2. Name of Operator
OXY USA INCORPORATED

8. Well Name and No.
WOOD DRAW 35 FEDERAL 3

9. API Well No.
30-015-35568-00-S1

OXY USA Inc. - Proposed
Wood Draw 35 Federal #3
API No. 30-015-35568

SUNDRY NOTICES AND REPORTS ON WELLS
Do not use this form for proposals to drill or to re-enter an abandoned well. Use form 3160-3 (APD) for such proposals.

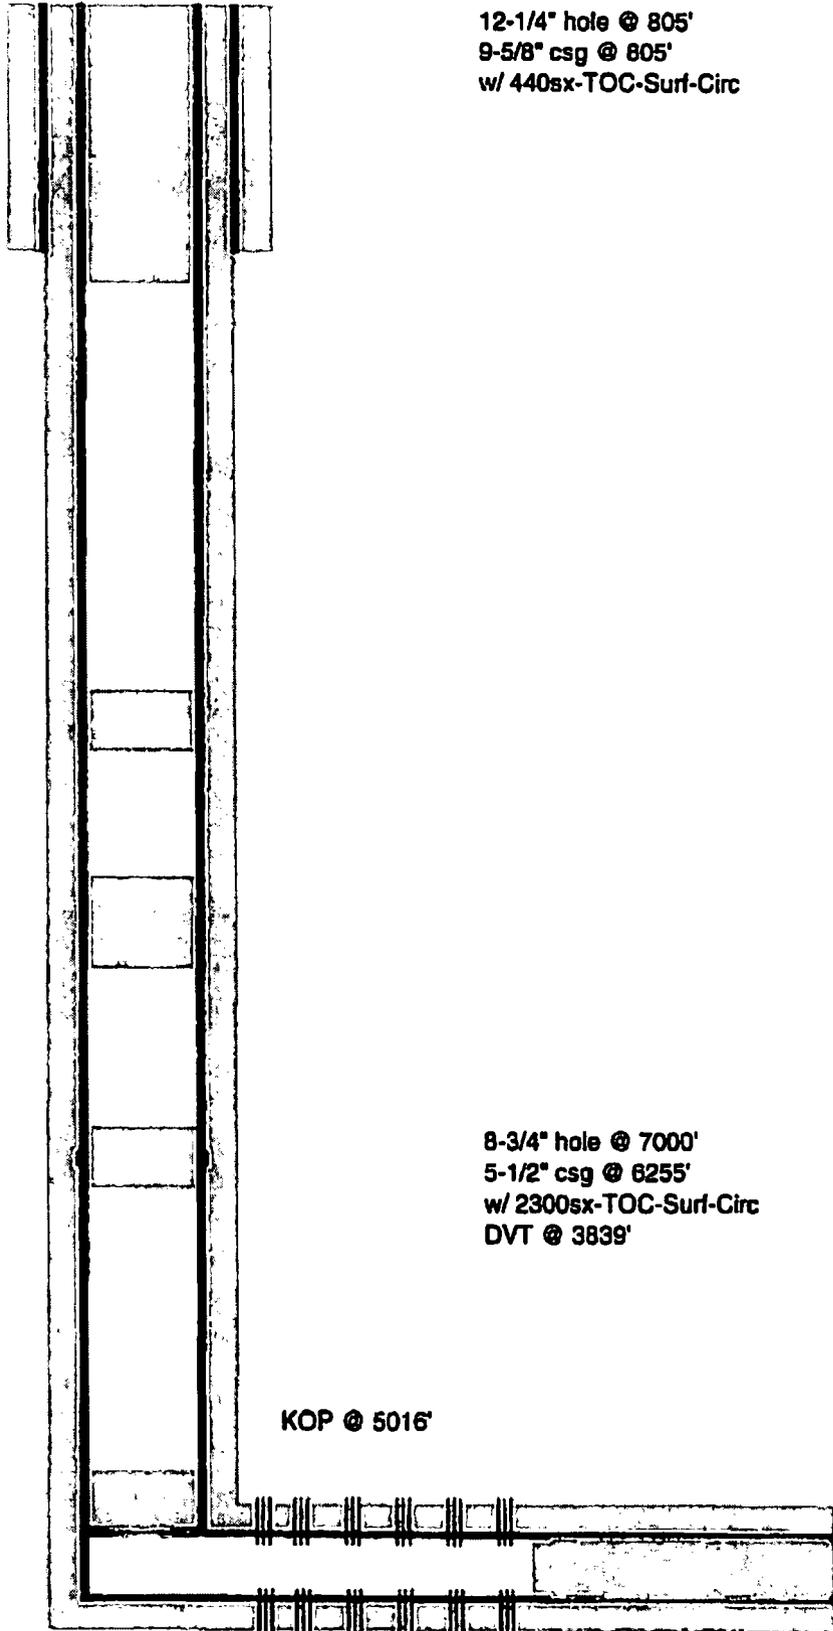
- 1. RIH & set CIBP @ 5397' w/ 25sx cmt to 5247'
- 2. M&P 25sx cmt @ 3890-3740' WOC-Tag
- 3. M&P 95sx cmt @ 3220-2970' WOC-Tag 3270-2970 (T/Del & B/L salt)
- 4. M&P 25sx cmt @ 2480-2330' WOC-Tag
- 5. M&P 110sx cmt @ 865' to surface 905 - Surf (T/Salt, shoe)
- 10# MLF between plugs - Above ground steel tanks will be utilized

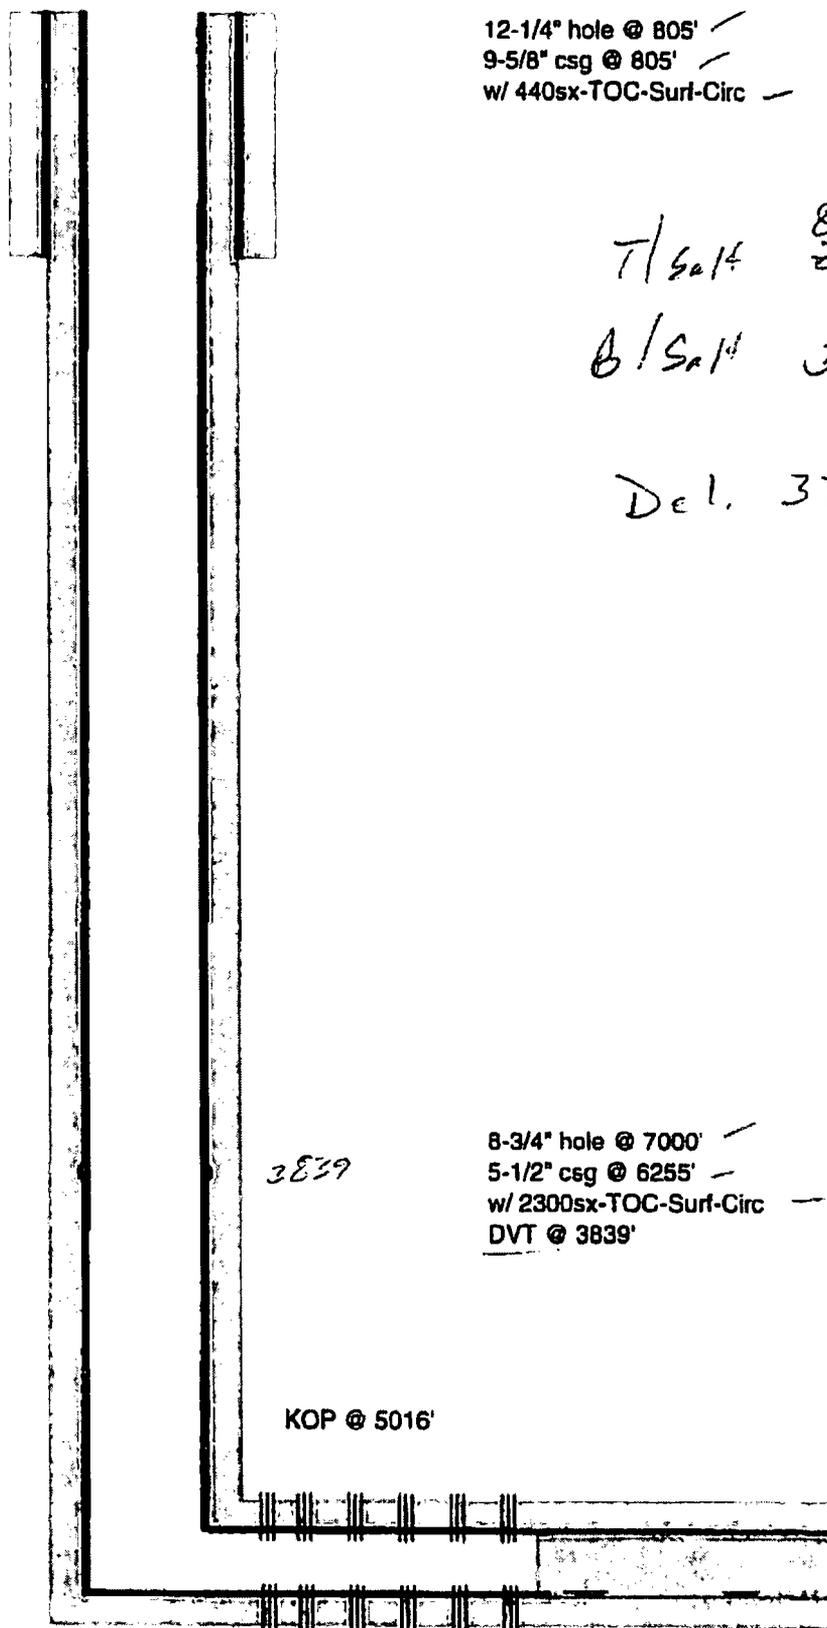
905
110sx @ 655'-Surface

40 3270-
35sx @ 3220-2970' WOC-Tag
